Product Change Notice (PCN)

PCN Number: PCN-0103212R-01

Product(s) Affected: SMI-EU-1, SMI-UK-1, SMI-AU-1

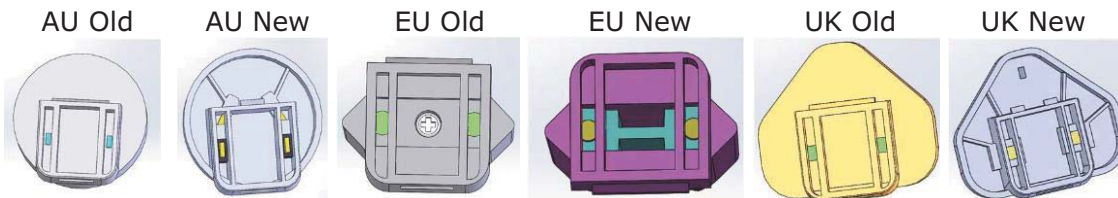
Description of Change: AU/EU/UK multi blade adapter blades will change from two piece ultrasonic welded construction to a one piece molded form.

Primary changes will be distinguished aesthetically on the back (connection side) of the blade.
